Access Compliance Report

Public Rights-of-Way

(Pedestrian Signals)

Intersection ID: N/A	Main Street:	Cross Street: N/A	Location: N/A
ADA ID: 8CB1D32A34AF	Signal Type: Two Push Buttons-Non APS	Overall Compliance: No	Severity Score: BTN 1:N/A BTN 2: N/A No BTN: N/A
Codes/Mitigation Info/Possible Solution		Field Measurements/Component Compliance

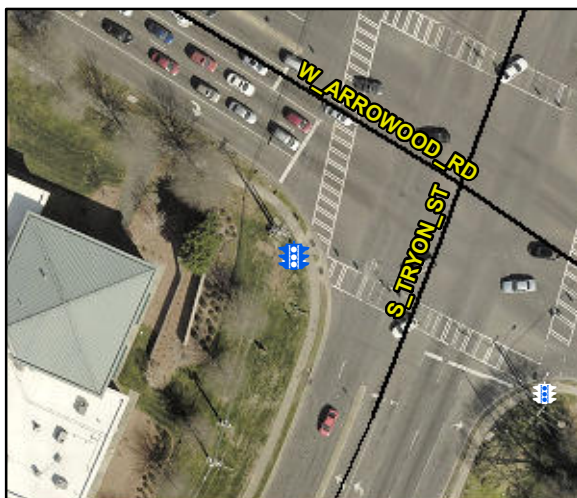
Compliance	Description	Data	Compliance	Description	Data
	Button Count	Button2	N/A	Distant to Additional Button (in)	N/A
	Additional Button Present?	N/A		Additional Button ID	N/A
N/A	Signal Buttons Required?	N/A	N/A	Additional Ped Posts Required	N/A
	How Many Ped Street Xings?	2		Located In An Island/Median?	No
N/A	B 1 Sign Present?	Yes	N/A	B 2 Sign Present?	Yes
Yes	B 1 Sign Purpose?	Yes	Yes	B 2 Sign Purpose?	Yes
Yes	B 1 Sign Lettering & Contrast?	Yes	Yes	B 2 Sign Lettering & Contrast?	Yes
Yes	B 1 Parallel To XWalk?	Yes	Yes	B 2 Parallel To XWalk?	Yes
Yes	B 1 PAR to Button?	Yes	Yes	B 2 PAR to Button?	Yes
Yes	B 1 PAR to XWalk?	Yes	Yes	B 2 PAR to XWalk?	Yes
Yes	B 1 Clear Floor Space?	Yes	Yes	B 2 Clear Floor Space?	Yes
N/A	B 1 FWD Approach?	Yes	N/A	B 2 FWD Approach?	No
N/A	B 1 FWD Approach Constrained?	No	N/A	B 2 FWD Approach Constrained?	N/A
Yes	B 1 FWD Approach Reach (in)	0.0	N/A	B 2 FWD Approach Reach (in)	N/A

N/A	B 1 FWD Approach Width (in)	N/A	N/A	B 2 FWD Approach Width (in)	N/A
N/A	B 1 FWD Approach Obstruction?	No	N/A	B 2 FWD Approach Obstruction?	N/A
N/A	B 1 FWD Approach Obstruction Dist (in)	N/A	N/A	B 2 FWD Approach ObstructionDist (in)	N/A
N/A	B 1 PARA Approach?	Yes	N/A	B 2 PARA Approach?	Yes
N/A	B 1 PARA Approach Constrained?	No	N/A	B 2 PARA Approach Constrained?	No
Yes	B 1 PARA Approach Reach (in)	3.5	Yes	B 2 PARA Approach Reach (in)	6.0
N/A	B 1 PARA Approach Width (in)	N/A	N/A	B 2 PARA Approach Width (in)	N/A
N/A	B 1 PARA Approach Obstruction?	No	N/A	B 2 PARA Approach Obstruction?	No
N/A	B 1 PARA Approach Obstruction Dist (in)	N/A	N/A	B 2 PARA Approach ObstructionDist (in)	N/A
No	B 1 Clear Floor Space Slope (%)	2.4	No	B 2 Clear Floor Space Slope (%)	3.1
No	B 1 Clear Floor Space XSlope (%)	3.2	Yes	B 2 Clear Floor Space XSlope (%)	0.9
N/A	B 1 PAR Slope (%)	2.2	N/A	B 2 PAR Slope (%)	1.9
Yes	B 1 Height (in)	38.5	Yes	B 2 Height (in)	38.5

Yes	B 1 Pressure (#)	2.0	Yes	B 2 Pressure (#)	2.0
Yes	B 1 Closed Fist Operation?	Yes	Yes	B 2 Closed Fist Operation?	Yes

Yes	B 1 Clear Xing Direction?	ClearlyMarked	Yes	B 2 Clear Xing Direction?	ClearlyMarked
	B 1 Crossing Direction	To N		B 2 Crossing Direction	To SE
Yes	B 1 DistanceTo XWalk (in)	0.0	Yes	B 2 DistanceTo XWalk (in)	0.0
No	B 1 DistanceTo Curb (in)	108.0	No	B 2 DistanceTo Curb (in)	122.0
No	B 1 Diameter (in)	2.5	Yes	B 2 Diameter (in)	2.5

Is Button 1 APS or Non-APS?	NonAPS	Is Button 2 APS or Non-APS?	NonAPS
N/A B 1 VibroTact Arrow?	N/A	N/A B 2 VibroTact Arrow?	No
N/A B 1 VibroTact Parallel to Xing?	N/A	N/A B 2 VibroTact Parallel to Xing?	N/A
N/A B 1 VibroTact Contrast	N/A	N/A B 2 VibroTact Contrast	N/A
N/A B 1 Pilot Light?	N/A	N/A B 2 Pilot Light?	No
N/A B 1 Pilot Light Illumination?	N/A	N/A B 2 Pilot Light Illumination?	N/A
N/A B 1 Verbal Walk Cycle?	N/A	N/A B 2 Verbal Walk Cycle?	No
N/A B 1 Verbal Message Audible?	N/A	N/A B 2 Verbal Message Audible?	N/A
N/A B 1 Locator Tone?	N/A	N/A B 2 Locator Tone?	No
N/A B 1 Percussive Walk Cycle?	N/A	N/A B 2 Percussive Walk Cycle?	Yes
N/A B 1 Extended Press Feature?	N/A	N/A B 2 Extended Press Feature?	No
N/A B 1 Tone Audible Range?	N/A	N/A B 2 Tone Audible Range?	N/A

Possible Solutions: Replace Signal Push Button With APS Button on New Post. Remove & Relocate Sign.

PROW/ADA: TMUTCD 4e.08, R404.2, R404.3, DMS-11132
